# PERMIT

SEWAGE DISPOSAL SYSTEM

**HOWARD COUNTY**  
BUREAU OF ENVIRONMENTAL HEALTH  
461-9933

SUBDIVISION Cat Tail ~~Field~~ Farms ROAD 4078 Route 97 LOT \_\_\_\_\_

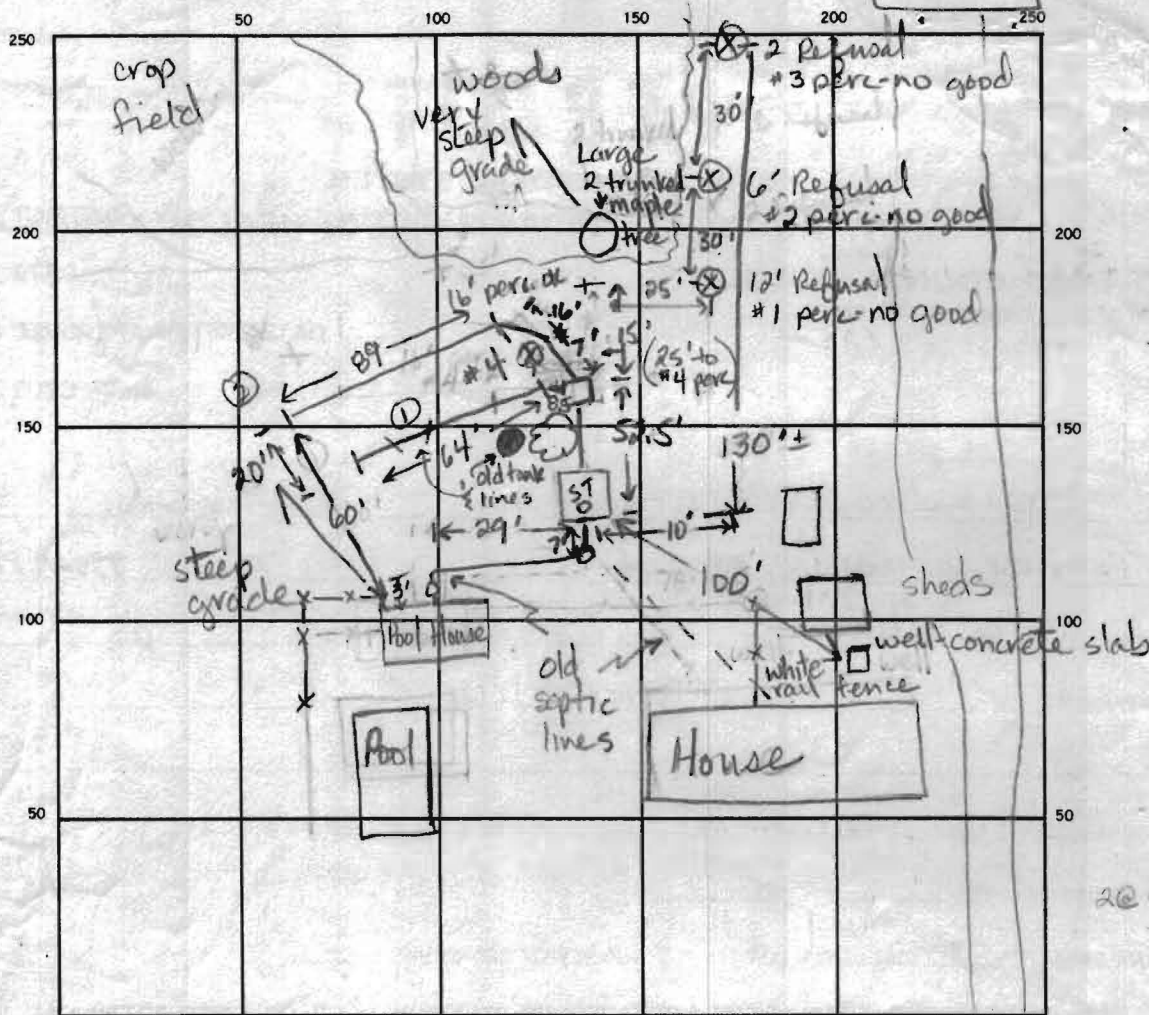
Old tank  
4 ft diam,  
5 ft high  
~ 400 gal.  
Old septic  
trench lines  
and far end  
of new  
system are  
2.0 to 2.5  
feet deep,  
dry. Closer  
pipe about  
2.0 feet  
deep but  
wet.

(subtract 6' x 12'  
and 4' x 5' of  
hard soil at  
base of 2nd  
trench) =  
1132 sq. ft.

REMARKS 6-16-87 Old metal septic tank was pumped out. Was blocked up and collapsed at sides. Old field abandoned. New tank installed re: R/H specifications on front. Four percs tested, 3 higher holes hit refusal at 2 ft to 12 ft. Passing perc located between trenches. Ok to add stone to trench ①. JEN

6-17-87 Ok to add stone with pipe to second trench. JEN

Ok to cover both trenches and boxes. 6-17-87 JEN

COVER NO WORK UNTIL INSPECTED AND APPROVED. PERC HOLES

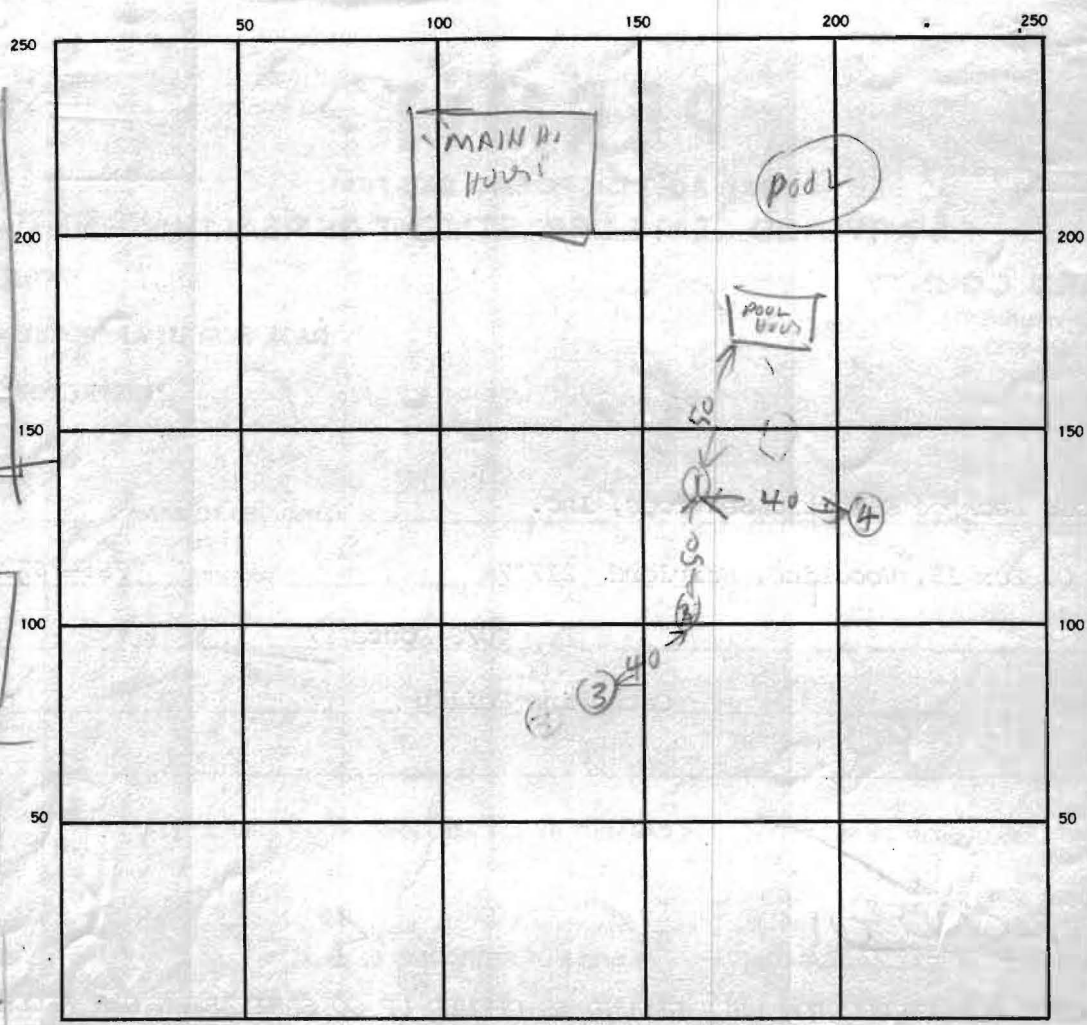
Deep TRENCH - 14 FT DEEP 2 FT WIDE 8 FT STONE  
EFFECTIVE AREA 8 INET 6 FT BELOW GRADE 200 SPT  
LALET THE TRENCH AT PERC HOLE (4) LOCATED  
50 FT BEHIND THE POOL HOUSE & LOWER  
THAN THE POOL HOUSE RUN TRENCH ON  
LEVEL GROUND AWAY FROM FAULT

HOLE ELEV  
 (1)(2)(3) - HIGH  
 (4) - LOW
